RESOLUTION NO. 2022-84

MEMORANDUM

Re: The Glen At Waters Edge Preliminary Plat – SW ¼ Section 16 & NW ¼ Section 21 Range 23 East Town 4 North Parcel ID's 51-104-04-23-16-021-000, 51-104-04-23-21-016-000, 51-104-04-23-21-016-010, & 51-104-04-23-21-021-000

PRELIMINARY PLAT

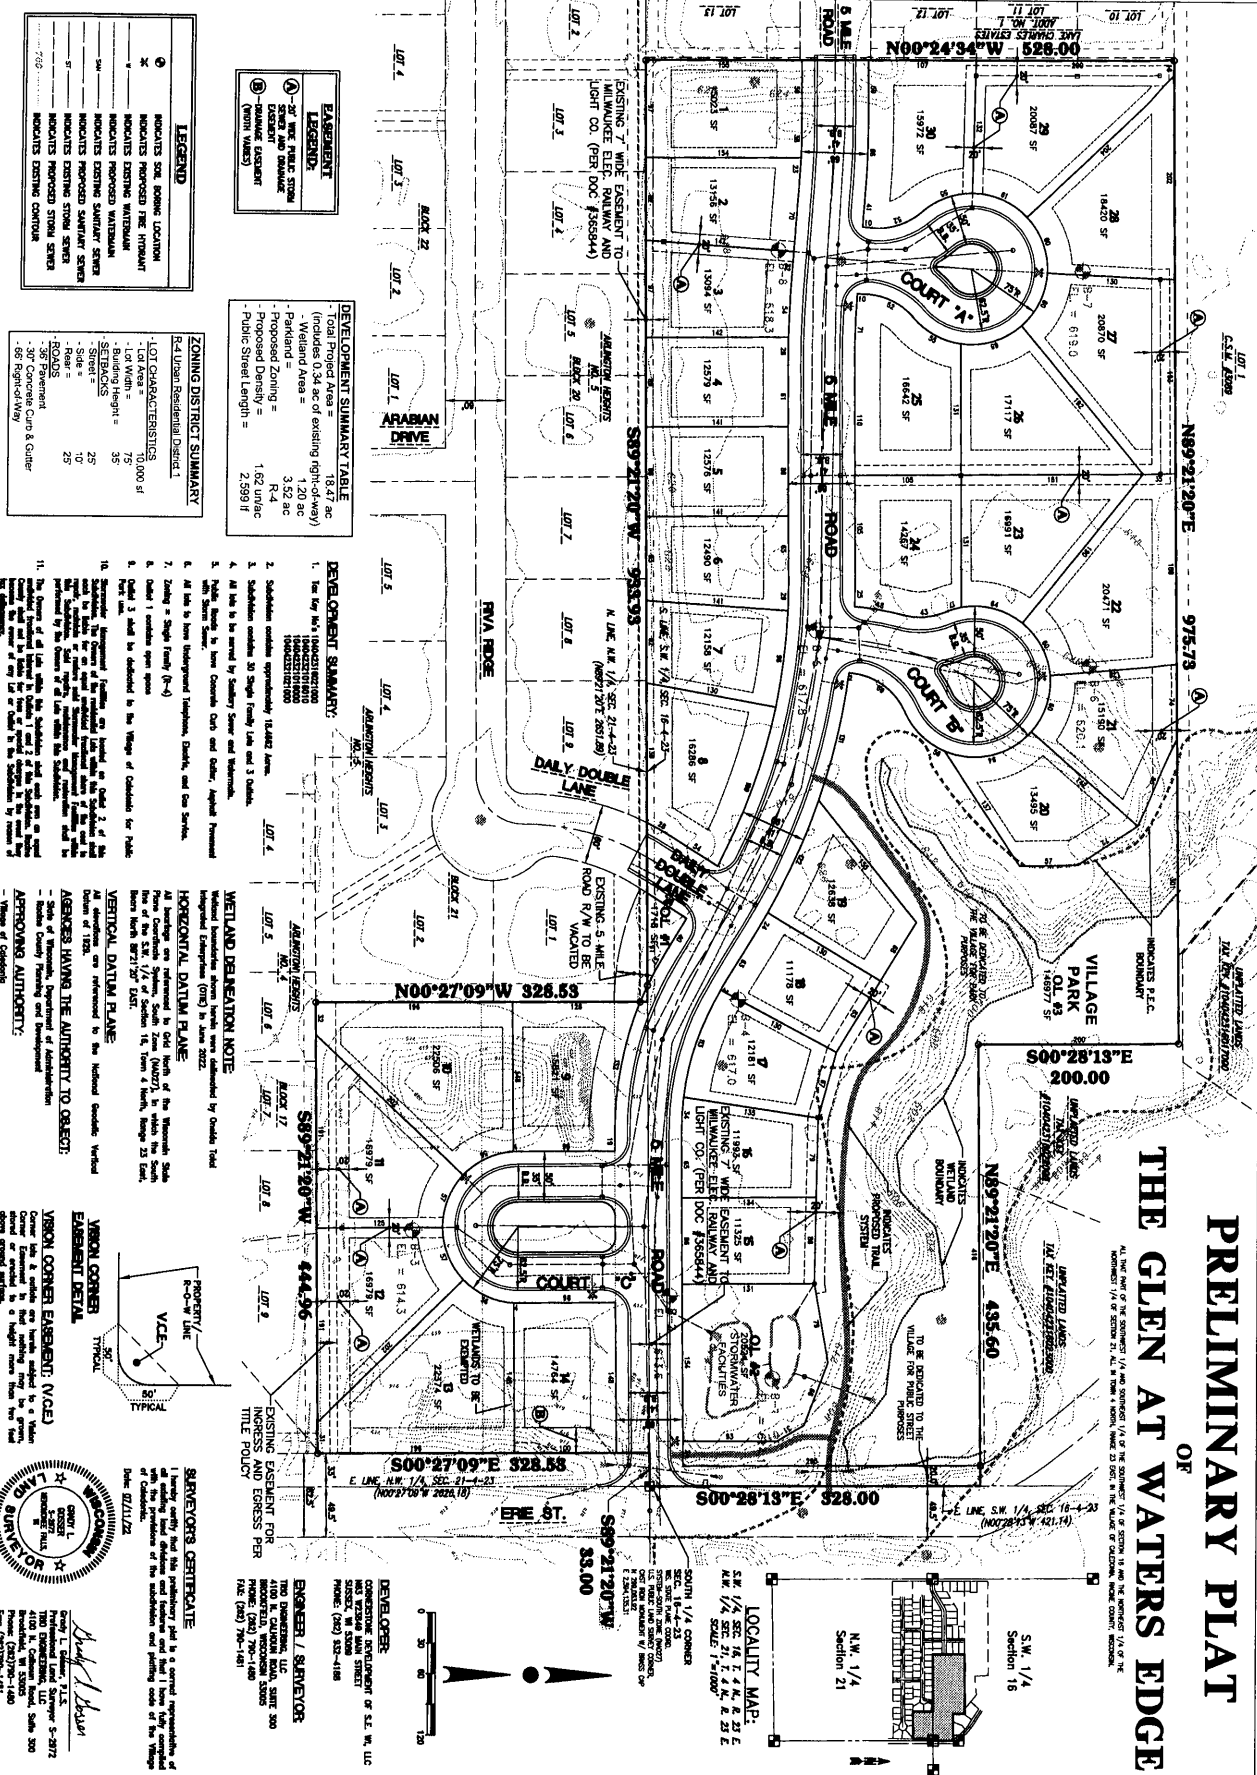
5 Mile Road is considered a principal throughfare. Typically, a principal throughfare would require a 90' Right of Way. With an Urban Arterial Road Cross Section from the Ordinance, a 70' Right of Way would be sufficient. The 70' Right of Way would also match the Right of Way width on 5 Mile Road in Lake Charles Estates (subdivision immediately to the West). A 70' Right of Way for 5 Mile Road should be granted.

The 3 proposed cul de sacs are considered local roads. 66' of Right of Way would be appropriate for the straight sections of the cul de sacs. The proposed cul de sacs have 75' Radii for the Right of Way. The Radii of the cul de sacs shall be 80'.

The Preliminary Plat will need to be revised to update the Right of Way as indicated above.

Access for the parcels shall be limited to 1 access per single family lot. There shall be 50' No Access restrictions placed at the intersection of all corner lots (Lots 8, 9, 14, 24, 25, & 30). There shall be No Access Restrictions placed along 5 Mile Road on the lots with secondary frontage on 5 Mile Road (Lots 9, 14, 24, 25, & 30. Lot 8 shall be allowed access to 5 Mile Road due to insufficient frontage on Daily Double Lane.). There also shall be No Access Restrictions placed along Waters Edge (Lots 13 & 14).

In addition to No Access Restrictions there also will need to be 25' x 25' Vision Triangle Easements placed at the intersections of all corner lots (Lots 8, 9, 14, 24, 25, & 30). The detail provided will need to be adjusted as necessary and the easements will need to be shown on the lots.

- **Correct the Road name from Erie Street to Waters Edge.**
- **Add Names for Cul De Sacs.**
- **Addition of the Owner of the Parcels. Include name, address, and telephone number.**

- **Addition of all platted Right of Ways within 300' of the Plat (Silent Sunday Court, North Pointe Drive & Waters Edge).**
- **Addition of all public and private easements within 300' of the Plat.**

- **Provide ownership information for lots within 100' of the Plat.**
- **Designate areas of slopes greater than 12%.**
- **Note if there are any Burial, Historical, or Cultural Resources on the property.**

- **A legal description of the parcels.**
- **Provide Density calculations for the Plat.**
- **Primary Environmental Corridor will need to be confirmed by SEWRPC.**

- **Wetland Buffers/Setbacks and uses are shown as necessary. Add Notes describing the maintenance (e.g., No Mow) of the Wetland Buffer. Also add Notes as necessary for what uses can be done in wetland buffers.**

- **Adjust Lot 17 to remove Primary Environmental Corridor from the Lot.**
- **The Right of Way width of 5 Mile Road shall be 70'.**
- **The Right of Way for the local streets shall be 66'. Radii for the cul de sacs shall be 80'.**

- **Adjust the road widths for 5 Mile Road and the 3 cul de sacs to the required widths by the Ordinance. (Urban Arterial Road & Urban Cul de sac)**
- **Addition of a Note for all parcels being limited to 1 access.**

- **50' No Access Restrictions placed on the lots at the intersections (Lots 8, 9, 14, 24, 25, & 30).**
- **No Access Restrictions placed along 5 Mile Road on lots with secondary frontage on 5 Mile Road (Lots 9, 14, 24, 25, & 30. Lot 8 shall be allowed access to 5 Mile Road due to insufficient frontage on Daily Double Lane.).**

- **No Access Restrictions placed on Waters Edge (Lots 13 & 14).**
- **25' x 25' Vision Triangle Easements placed on the lots at the intersections (Lots 8, 9, 14, 24, 25, & 30). Adjustment of the detail for Vision Corner Easement for distance and that there shall be nothing grown, stored, or erected to a height more than 6" above the ground surface.**

- **Addition of a note for Outlot 2 being used for Storm Water purposes and being a Storm Water Easement. In addition, this will require a separate Storm Water Easement to be recorded to cover liability, maintenance, and a maintenance schedule.**

- **The granting of a 12' Drainage & Utility Easement along the exterior boundary of the subdivision. This will not be required along Outlot 1 or Outlot 3.**

- **Will need to add Utility Easements to the Plat when Utility layouts have been completed.**
- **Add Note on the Plat for restricting trees, plantings, buildings, berms, fences, etc. in easement areas and Right of Ways.**

- **Review and approval of the Site Grading & Drainage Plans by the Engineering Department, Caledonia Utility District and Village Board.**
- **Add Note on the Plat that Driveways shall not have a centerline slope steeper than 6%.**

- **Add Note on the Plat that “Lots have been filled greater than 3 feet and may require additional courses in the foundations to reach suitable soil. Will need to provide a soil compaction certification for the areas of greater than 3 feet of fill.”**
